Calculation 98-ENG-02405D2, Revision 2

Item Equivalency Evaluation Title/Station/Unit MINCO S7927 RTD, BURNS MODEL WSP / Millstone / Unit 2	IEE Number 1000008752	Version V00
Approvals: (N/A blocks not required)		
Preparer Procurement Engineer (Print) P. Wynn	Signature 	Date 9/28/09
Independent Procurement Engineer (Print) R. Malinowsky	Signature 	Date 9/29/09
Peer Review/Design Authority (Print) DVCLEMONS	Signature 	Date 10/6/09
Other/Reviewer/Affiliation (Print)	Signature	Date
Other/Reviewer/Affiliation (Print)	Signature	Date
Other/Reviewer/Affiliation (Print)	Signature	Date
Other/Reviewer/Affiliation (Print)	Signature	Date

Item Equivalency Evaluation Title/Station/Unit MINCO S7927 RTD, BURNS MODEL WSP / Millstone / Unit 2	IEE Number 10000008752	Version 00
---	---------------------------	---------------

Figure 3-1

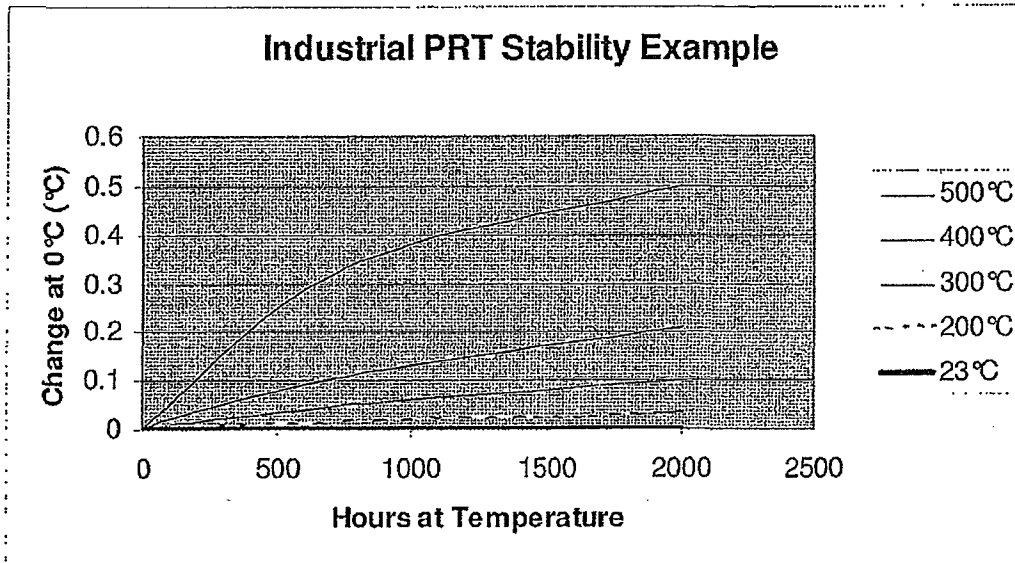
73.4°F

Service water temperature < 25°C

Stability: The stability of the replacement item is not specified. A review of Burns Engineering Technical Paper on stability, attached to this IEE, shows that the stability of a platinum resistance thermometer (PRT) at the service water system temperatures can be ignored as a potential error source. This item is acceptable.
